UNITED STATES PATENT AND TRADEMARK OFFICE

| APPLICATION NO. | FILING DATE | FIRST NAMED INVENTOR | ATTORNEY DOCKET NO. | CONFIRMATION NO. |
|-----------------|-------------|----------------------|---------------------|------------------|
| 10/020,275 | 12/18/2001 | Walter Takeo Yagyu | 08200.608 | 9120 |

Office Action Summary

DETAILED ACTION

FIG. 6

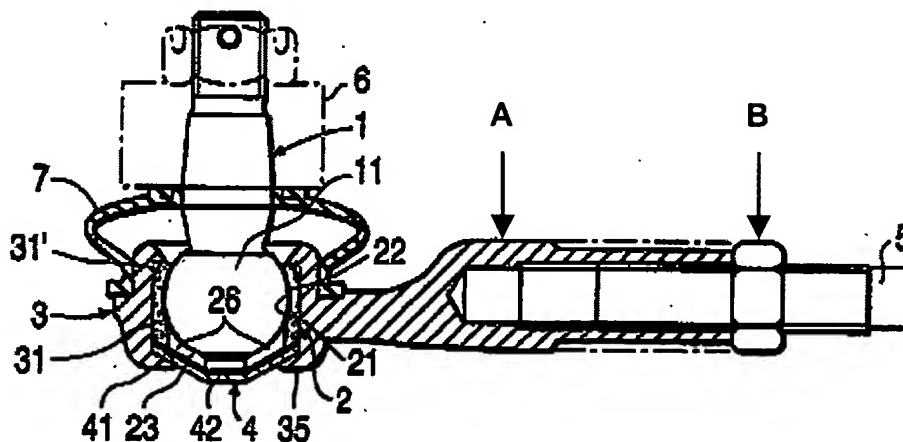
As to claim 1, Shimizu et al. disclose a tie rod comprising a stem 5 provided at its ends with ball joints 3 each composed of a metallic ball joint box A (box A of ball joint 3 has a metallic cross-hatching; Figure 6 reprinted below with annotations), a bearing 2, a protection cover 7 and a ball pin 1, the tie rod having the function of fixing pieces and components of a mechanical system between themselves, providing to them angular and rotational movement, supporting the strains concentrated therein, wherein the stem of the tie rod is combined with components of the metallic ball joint box (Figure 6).

As to claim 3, Shimizu et al. disclose a tie rod wherein ball joints **3** are attached to the ends of a stem **5** by means of a thread on the body of the stem and in the ball joints' boxes **A**, making the tie rod a tie rod with variable length, the adjustment of its

length and the locking of the tie rod being provided by nuts **B** provided on the threads of the stem and that are tightened against the boxes of the ball joints (Figure 6).
